**Flood Control Project Maintenance
Levee Inspections**

Fall 2018 Levee Maintenance Deficiency Summary Report

Sacramento Maintenance Yard West Levee Yolo Bypass

Levee Inspection Report By Mile - Fall 2018

Photo 2 of 2 : FA_2018_ST0011_291_9_20180904_00004.jpg

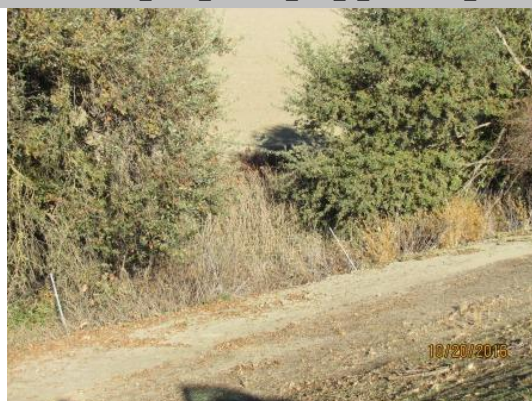
LM Start	1.70	Rating **	M	Issue No.	9
LM End	1.79	Issue Type +	En	Location *	LS
Category	Earthen Levee			GPS Latitude/Longitude	
				Start	End
Item	Encroachments			38.736842°	38.735498°
				-121.660285°	-121.660287°
DWR ID	DWR_ST0011_01_f_2016_9				
Comment Code					
FE : Fence					
Inspector Comment

Another view of fence along the ditch on landside. Fall 2016.

Photo 2 of 3 : UCIP_FA_2018_44822_24979.jpg

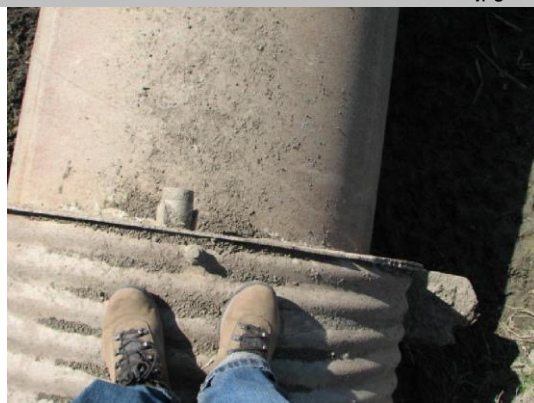
Comment Code					
Inspector Comment					
FS_ID:44822					
DS_ID:17736					
EP_NO: 10306					
Repair Type: No Action Needed					
Crossing Status: Found					
UCIP Comments: Farmer cleans this screw gate every year					
FIELD_STRUCT_DESC: 48-inch corrugated metal gravity drainage pipe through the levee, 21.5 feet below the crown. 42-inch steel pipe inside the 48-inch pipe. Flap gate on the waterside (WS) with two cutoff walls, one headwall, and one saddle and apron. (48-inch pipe [HLM 2.12] authorized under Automatic Board Order (ABO) issued as Permit No. 10306, 1974 - Wells Fargo Bank, Trustees for Cowell Foundation). [Additional Reference(s): USACE Sacramento O&M Manual 119, December 1952, (Station 80+00)].					
FS Date: 4/28/2015 2:57:49 PM

Landside view: closer look at 42-inch steel pipe and 48-inch CMP
